Access Compliance Report

Public Rights-of-Way

(Curb Ramps)

Intersection ID: 49930	Main Street: PAXTON_RUN_RD	Cross Street: CHAMBERLIN_RD	Location: NE
ADA ID: E8EFF787ED61	Ramp Type: Perp	Initial Pass/Fail: Fail	Overall Compliance: No
Severity Score: 1.25			
Codes/Mitigation Info/Possible Solution		Field Measurements/Component Compliance

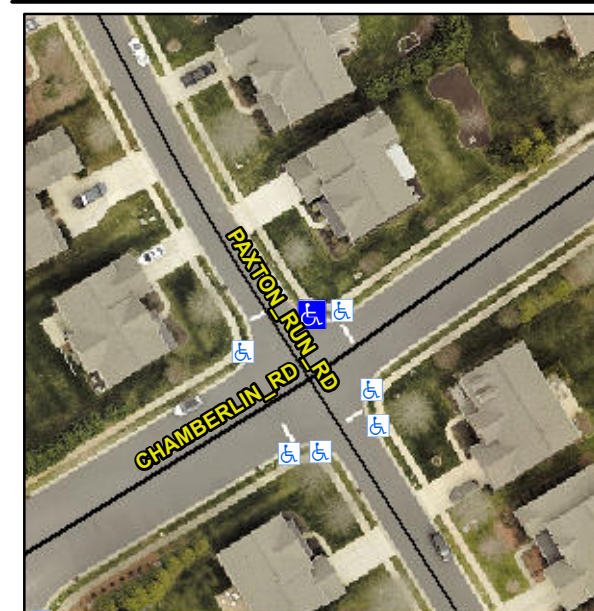
Not Found, R304.5.3

Compliance	Description	Data	Compliance	Description	Data
N/A	Ramp Length (in)	46.0	Yes	Ramp Slope (%)	6.9
Yes	Ramp Width (in)	48.0	No	Ramp XSlope (%)	2.9
N/A	Flare Type LT	N/A	N/A	Flare Type RT	N/A
N/A	Flare Slope LT (%)	N/A	N/A	Flare Slope RT (%)	N/A
N/A	Flare Traversable LT?	N/A	N/A	Flare Traversable RT?	N/A
N/A	Landing Length (in)	N/A	N/A	DWS Provided?	N/A
N/A	Landing Width (in)	N/A	N/A	DWS Contrast?	N/A
N/A	Landing Slope (%)	N/A	N/A	DWS Length (in)	N/A
N/A	Landing X Slope (%)	N/A	N/A	DWS Full Width?	N/A
N/A	Landing Curb? (Y/N)	N/A	N/A	DWS Offset (in)	N/A
N/A	Shared Landing?	N/A			
N/A	Gutter Ponding?	N/A	N/A	Gutter Slope (%)	N/A
N/A	Gutter Lip Ht (in)	N/A	N/A	Gutter X Slope (%)	N/A
N/A	Painted X Walk1?	No	N/A	Painted X Walk2?	N/A
	X Walk 1 Direction	To SW		X Walk 2 Direction	N/A
N/A	X Walk 1 Width (in)	N/A	N/A	X Walk 2 Width (in)	N/A
	X Walk 1 Slope (%)	0.0		X Walk 2 Slope (%)	N/A
	X Walk 1 X Slope (%)	1.9		X Walk 2 X Slope (%)	N/A

Remove & Replace Entire Ramp.
